PROJECT NO.	1002125	APPLICATION NO.	02 - 01611
PROJECT NAME	Reynolds Add.		
EPC APPLICATION NO.			
APPLICANT / AGENT	Kevin Georges	PHONE NO.	255-4975
ZONE ATLAS PAGE

DEVELOPMENT REVIEW BOARD TRANSPORTATION DEVELOPMENT Standard Comment Sheet

DRB-1002125

TO: Roger Green, Chair, Development Review Board
FROM: Len Malry, Planner, Development Services *[Signature]*
DATE: 10-23-02
SUBJECT: EPC CONDITIONS FOR PROJECT #1002125 (02EPC01157)

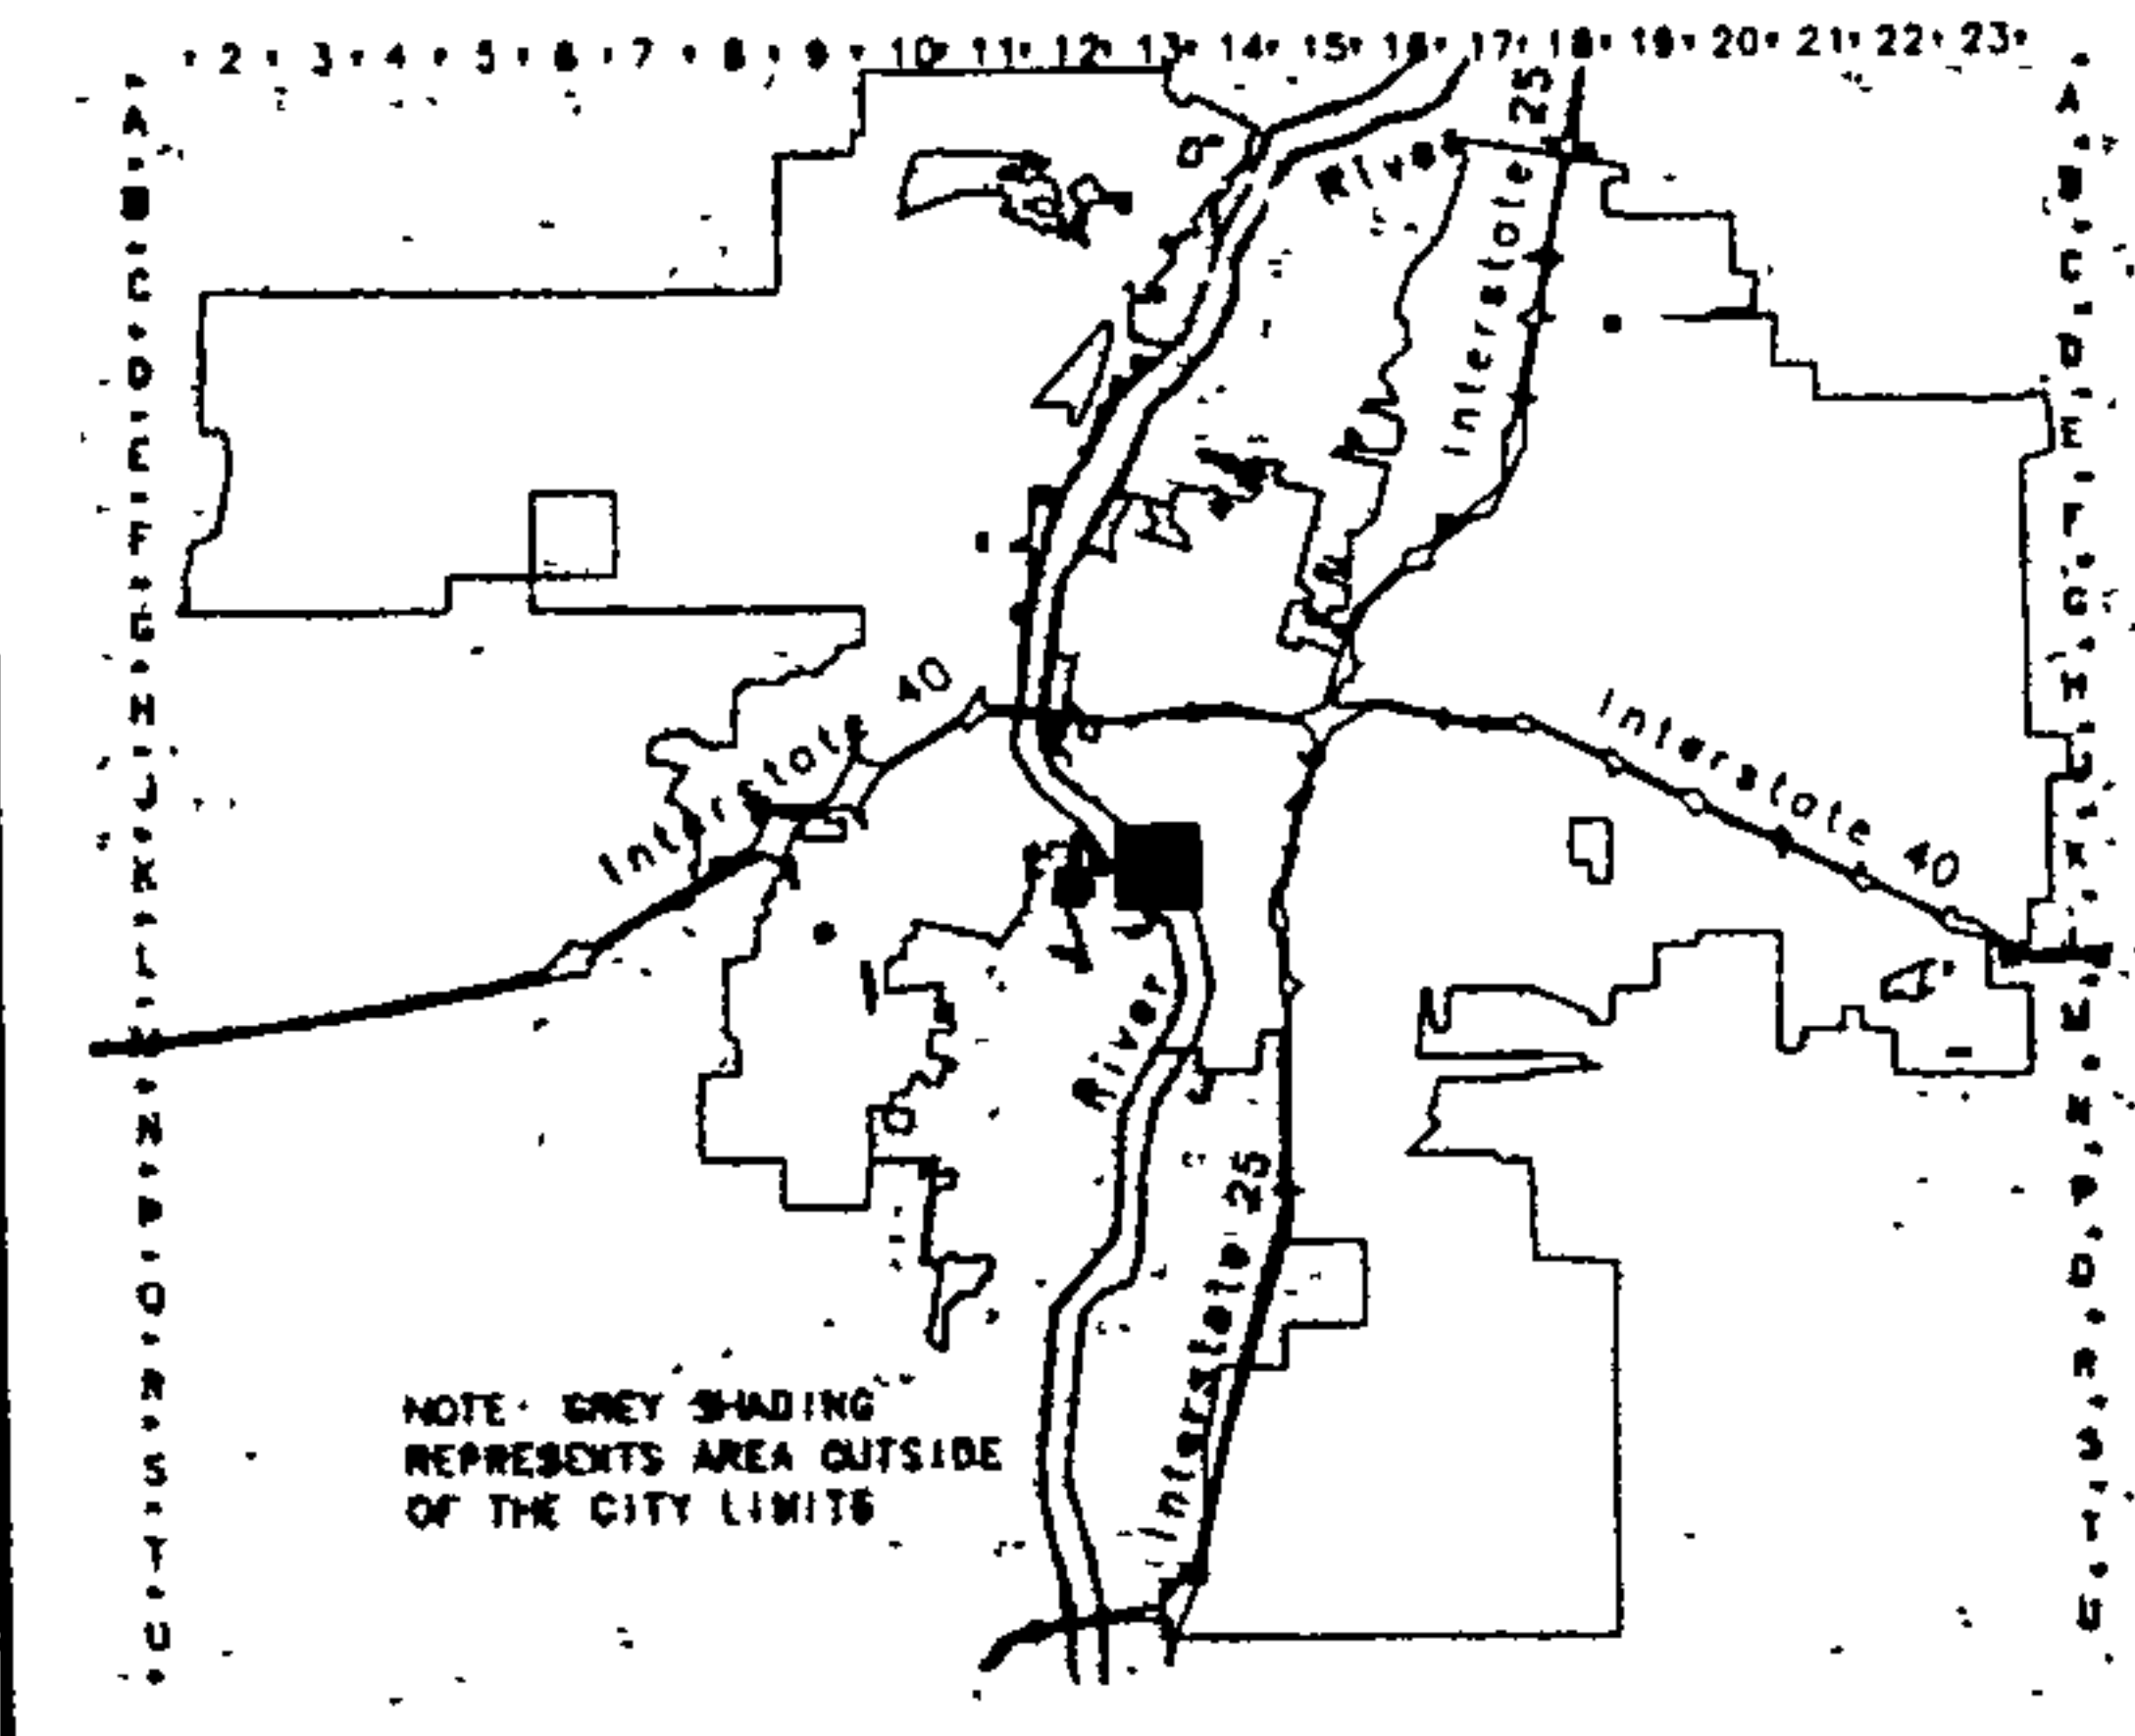
The elevations have been slightly revised to indicate a storefront door instead of a window at the south elevation, a double door instead of a single door at the west elevation, the removal of all scuppers except at the south elevation, and the use of stucco instead of EIFS. See A1.

**LOT 20-A, BLOCK 44
RAYNOLDS ADDITION**

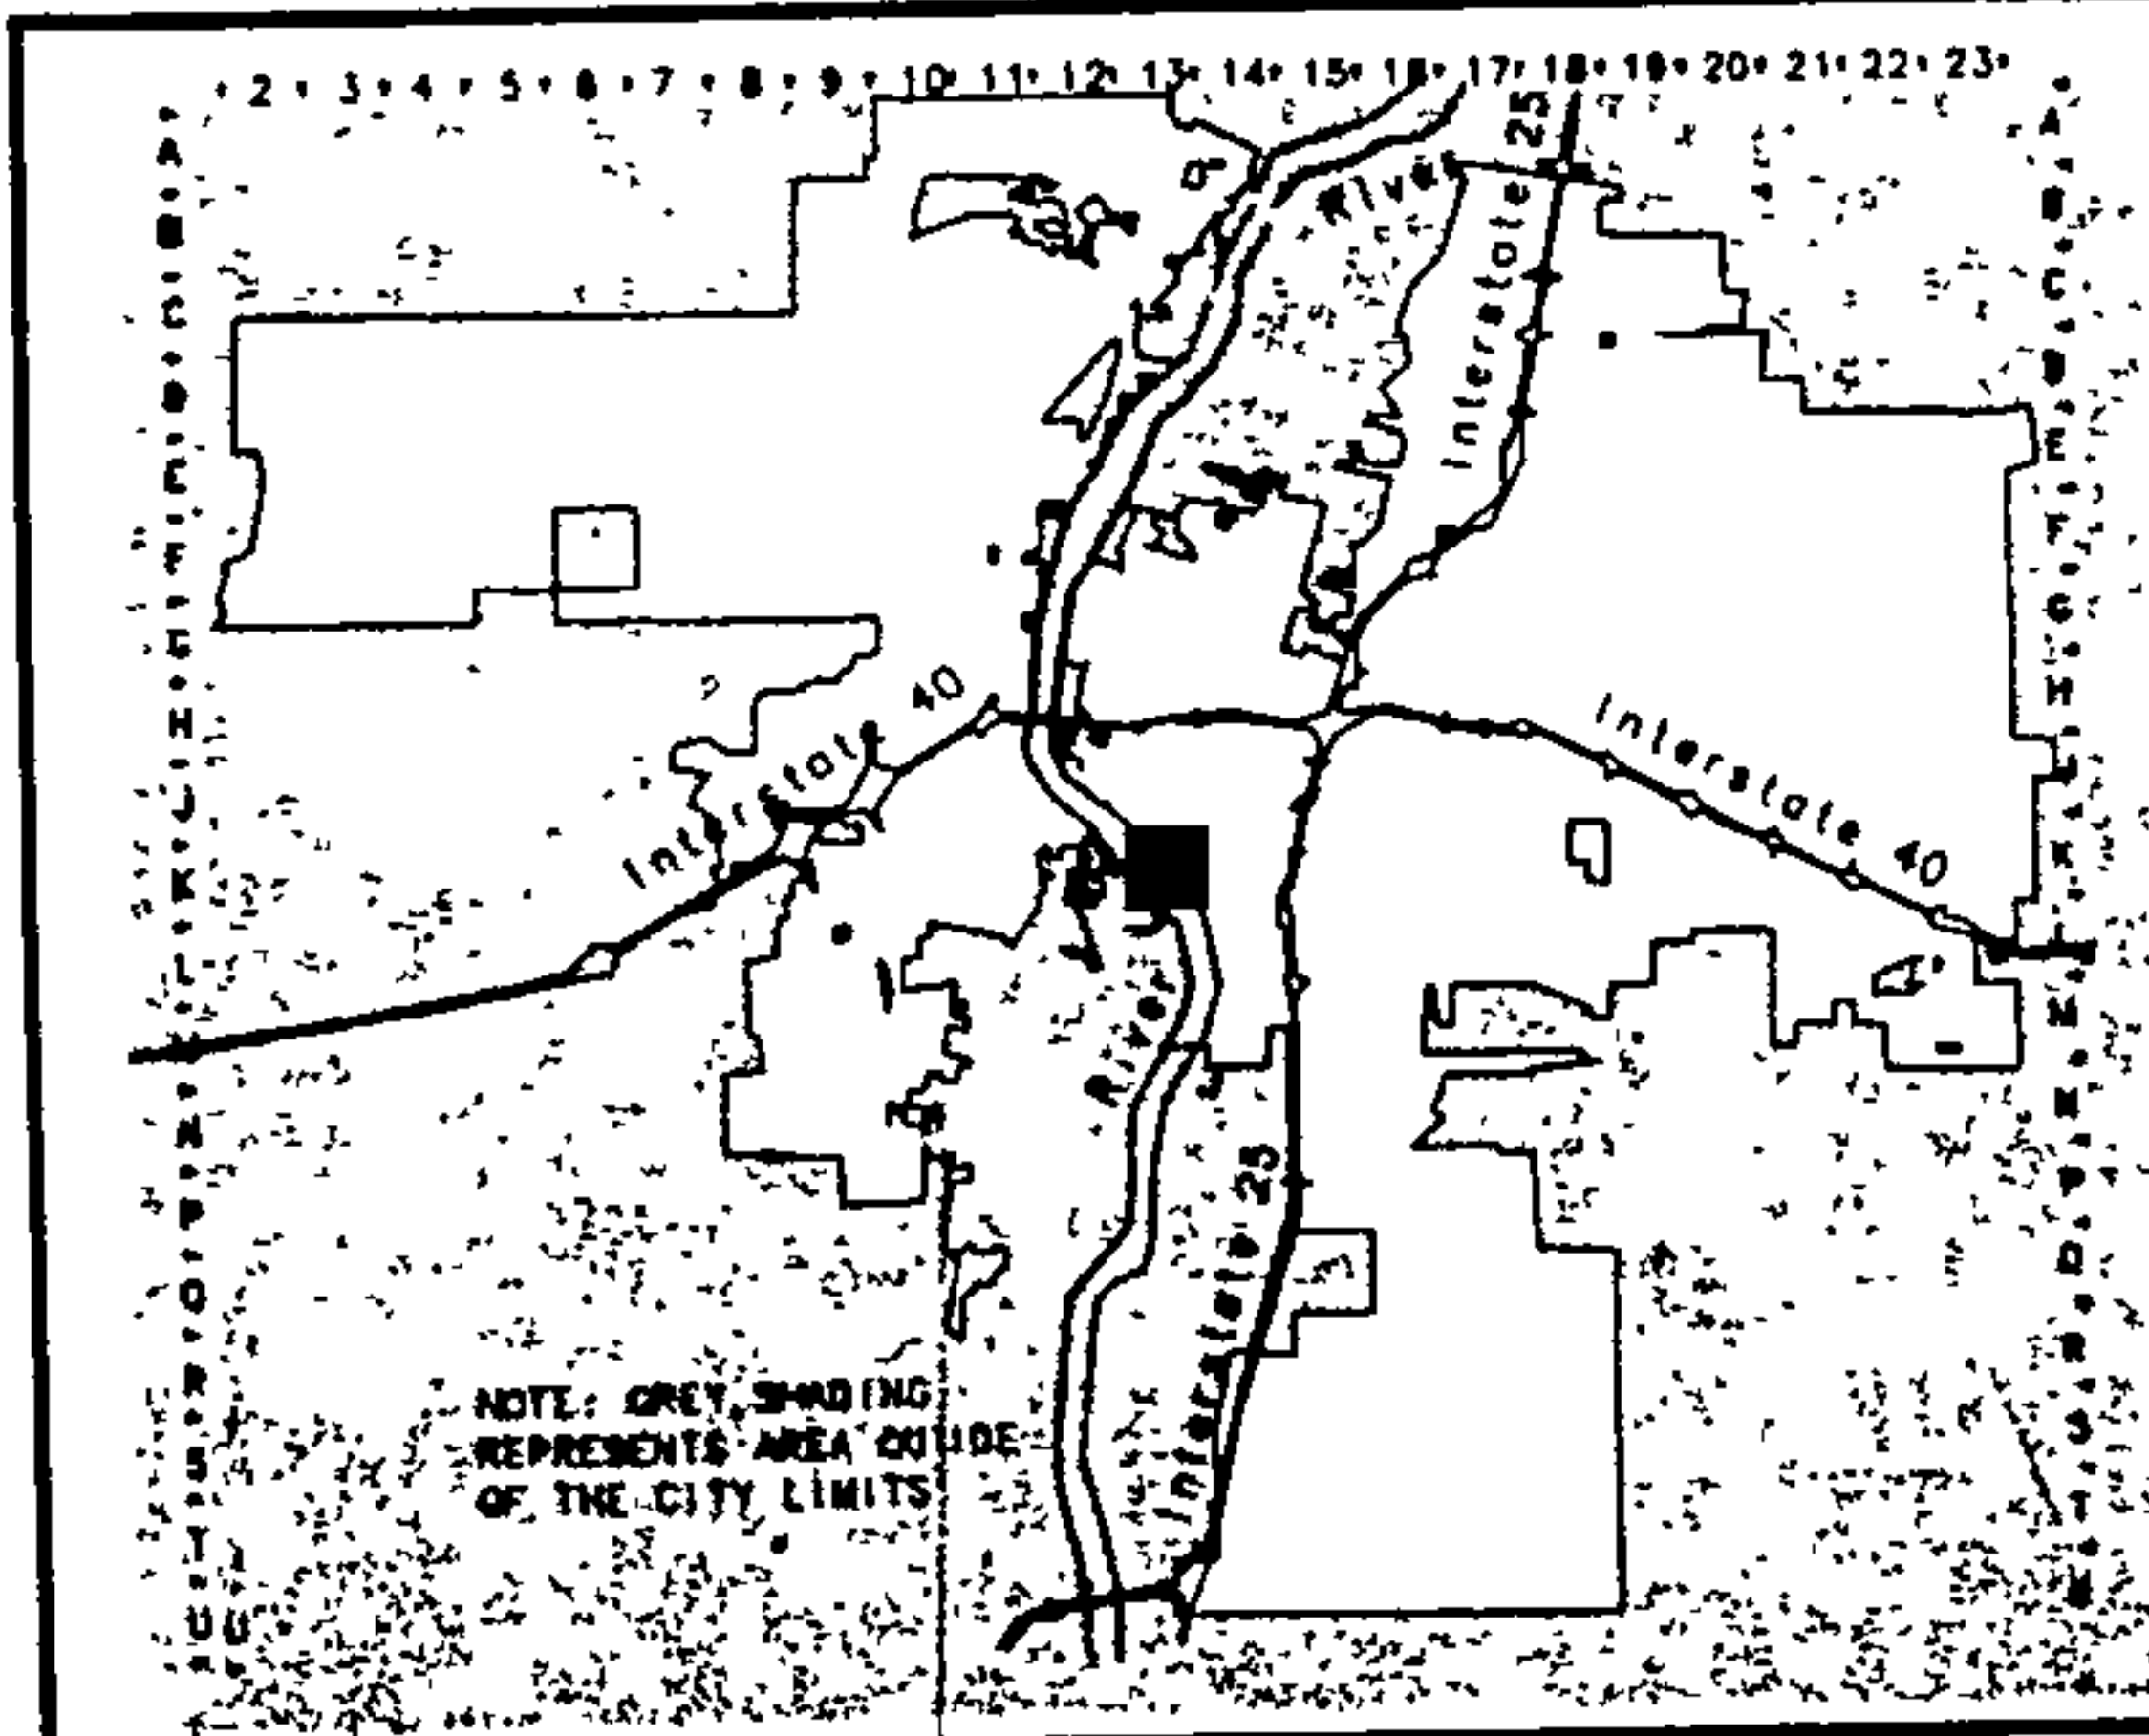
TRANSPORTATION DEV (505) 924-3990		
PLANS DISAPPROVED	DATE	DATE
PLANS APPROVED NSF	DATE 8/27/02	DATE
COMMENTS:		
- Provide clear sight triangle & note for unobstructed vision (14th St & Public Alley) w/in site triangle		
OK

PLANNING (505) 924-3858		
PLANS DISAPPROVED	DATE 8/15/02	DATE
PLANS APPROVED	DATE 9/17/02	DATE
COMMENTS:		
① The applicant on the application form is Kevin Georges & Associates. The proprietary interest was left blank. Georgia Chavez signed the plat on behalf of the St. Vincent de Paul Society. Please clarify and provide written documentation. ② Has a site development plan for subdivision been approved by the EPC? The site plan and plat must match and should be submitted concurrently to DRB. ③ The site lies within the boundaries of the Boulders Sector Development Plan.
